Sampling, Analytical and Quality Plan

One Rail

Berrimah Terminal

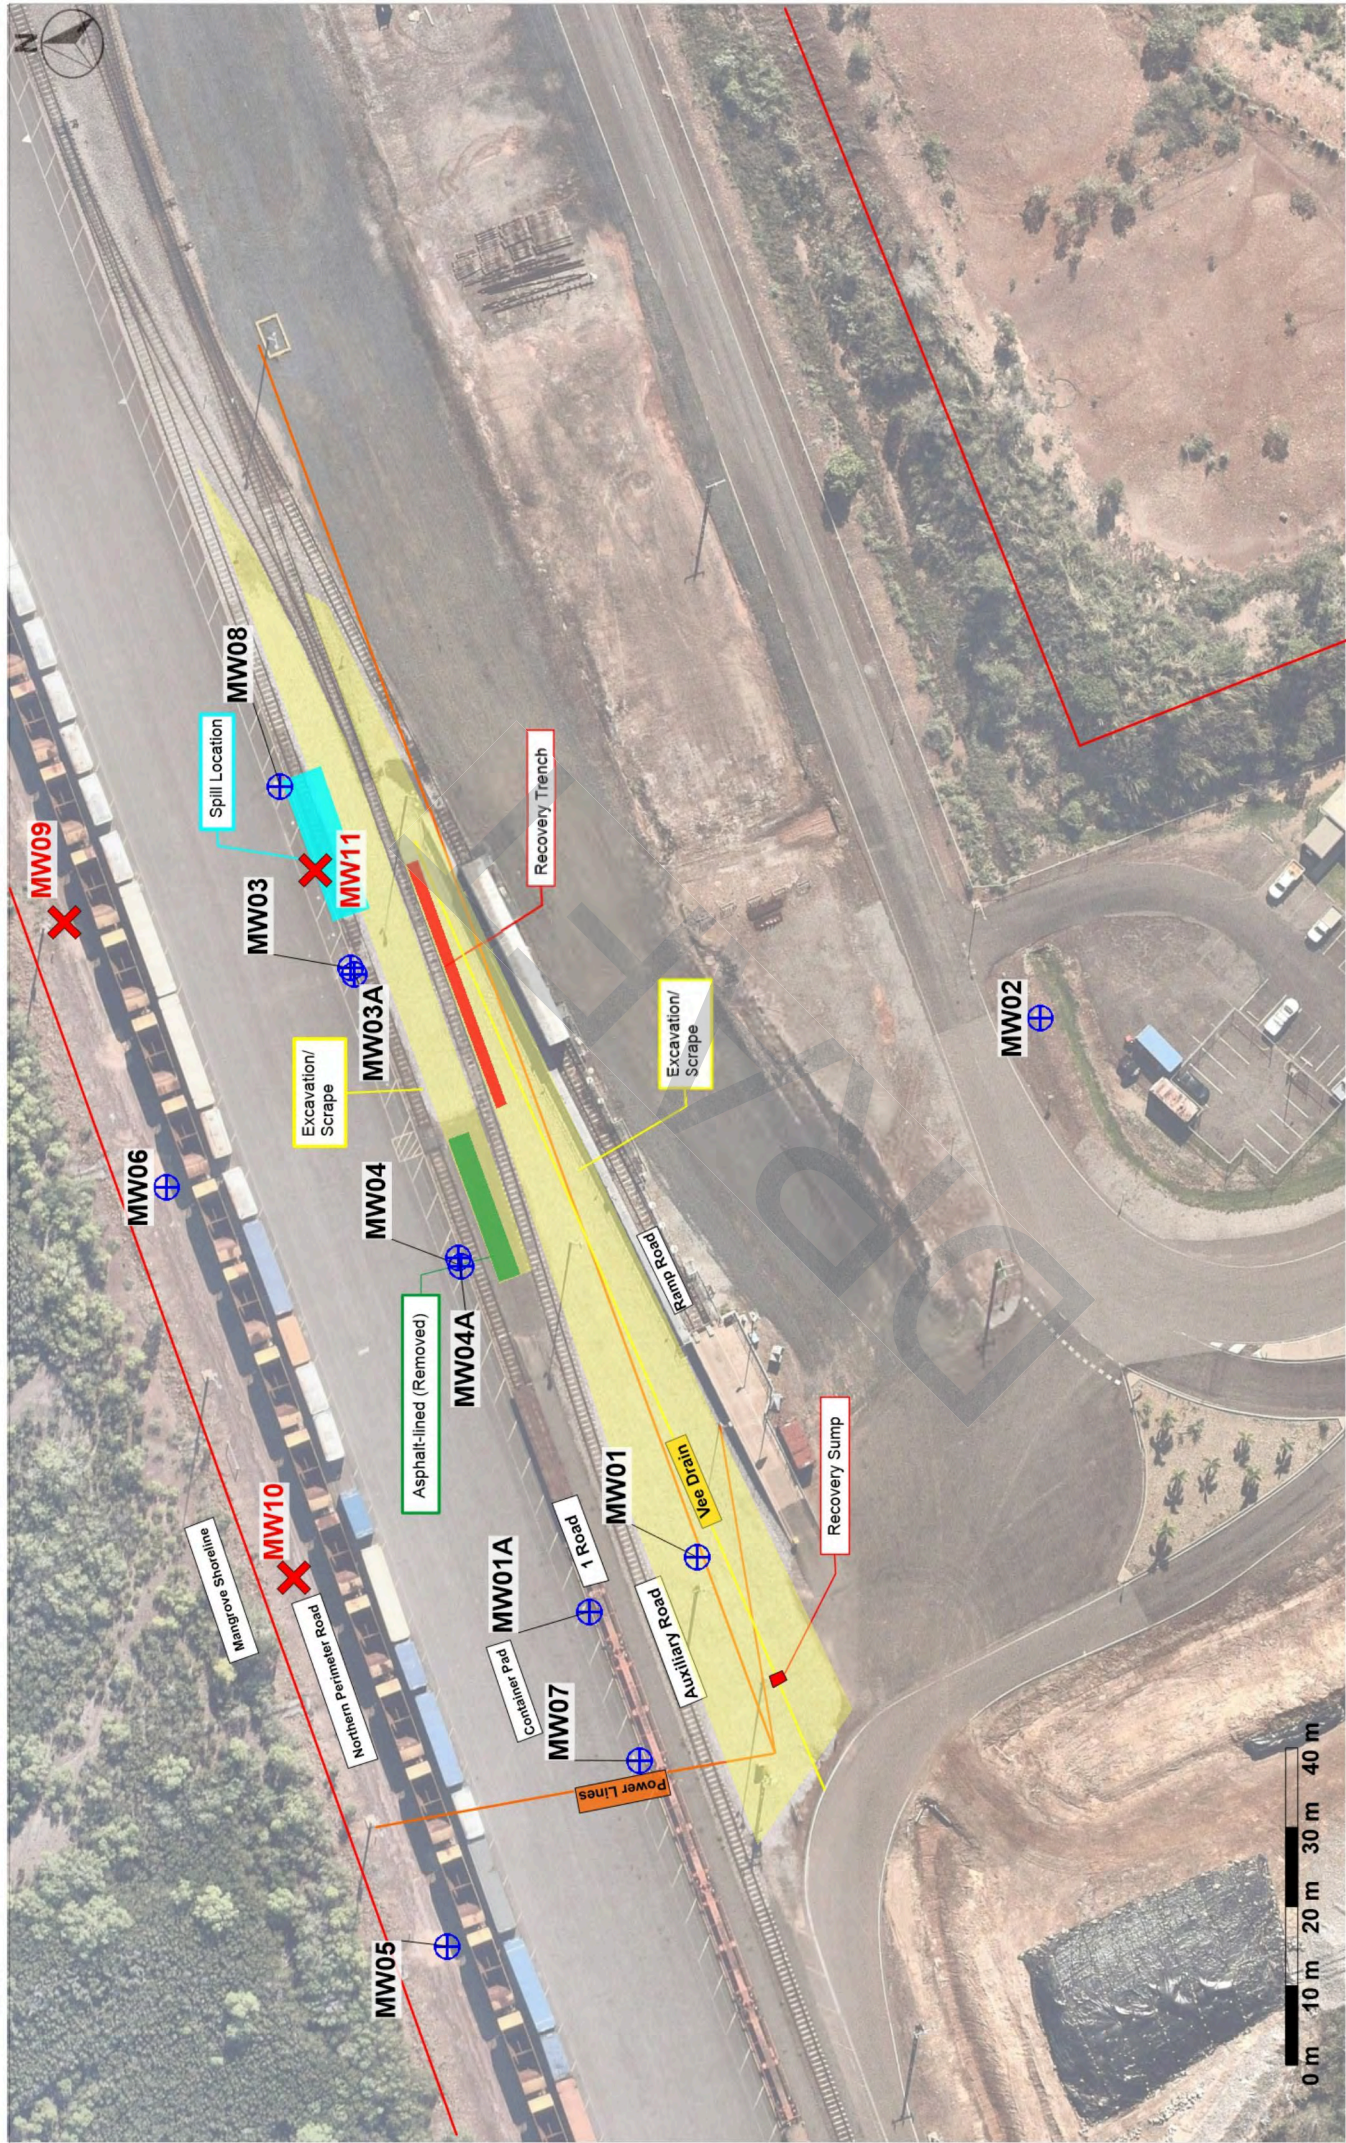
b. Groundwater:	
9	i. A significant mass of hydrocarbons remains in soil (>20,000 mg/kg C ₁₀ – C ₃₄ TRH) at and surrounding the spill area and to a lesser extent near the collection sump – which may form an ongoing source of groundwater contamination.	To be addressed via modelling, see Section 4.3.
10	ii. There are no monitoring wells located directly down hydraulic gradient of the spill area (i.e. northeast of MW06) and other areas where significant residual contamination remains (between MW05 and MW06).	To be addressed via installation and sampling of additional monitoring wells, see Sections 4.3 and 4.4.

Item	Auditor Comment	Action
11	iii. The potential for contaminated groundwater to migrate towards (and impact upon) the down gradient receptor in the future requires assessment.	To be addressed via installation and sampling of additional monitoring wells and modelling, see Item 10.

- The installation of three new wells onsite (MW09 to MW11). The proposed locations are shown on **Figure 4**.
- The sampling and analysis of groundwater from all onsite monitoring wells (MW01 to MW11).

- MW09 and MW10 – additional downgradient monitoring wells along the mangrove fringe to assess potential migration of contamination offsite.
- MW11 – immediately adjacent spill location.
